South Carolina  
Department of Transportation

DM0605

**MEMORANDUM TO TEAM LEADERS AND CONSULTANTS**

**SUBJECT:** Conduit in Barrier Parapets and Railing Walls

CONDUIT PLACEMENT DETAIL

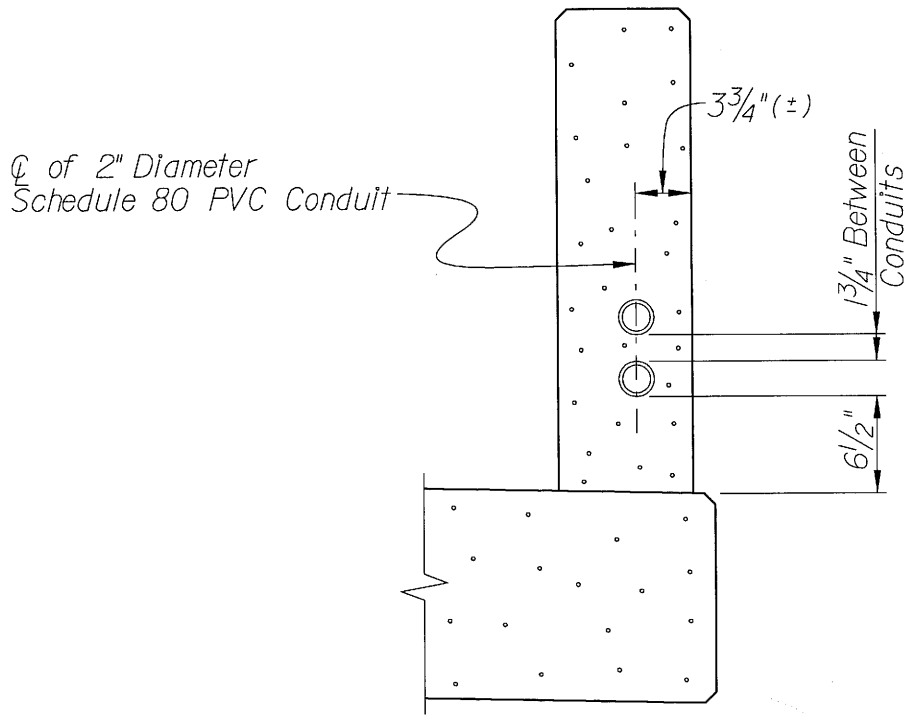
Effective with the April 2006 Letting, two 2-inch diameter conduits shall be detailed in all concrete bridge barrier parapets and concrete bridge railing walls as shown on the attached Detail. The following requirements shall be included in the bridge plans:

- Schedule 80 PVC rigid nonmetallic conduit shall be specified.
- The conduits shall extend 6 inches beyond each end of barrier parapet or railing wall.
- The ends of the conduits shall be capped with watertight covers.
- Expansion or deflection fittings, capable of accommodating anticipated movements and rotations, shall be specified at each open joint in the barrier parapet or railing wall.
- Pull boxes shall be detailed for any conduit lengths in excess of 300 feet.
- Pull boxes shall be non-metallic or galvanized steel and shall be mounted in the barrier parapet or railing wall, flush with the outside face.
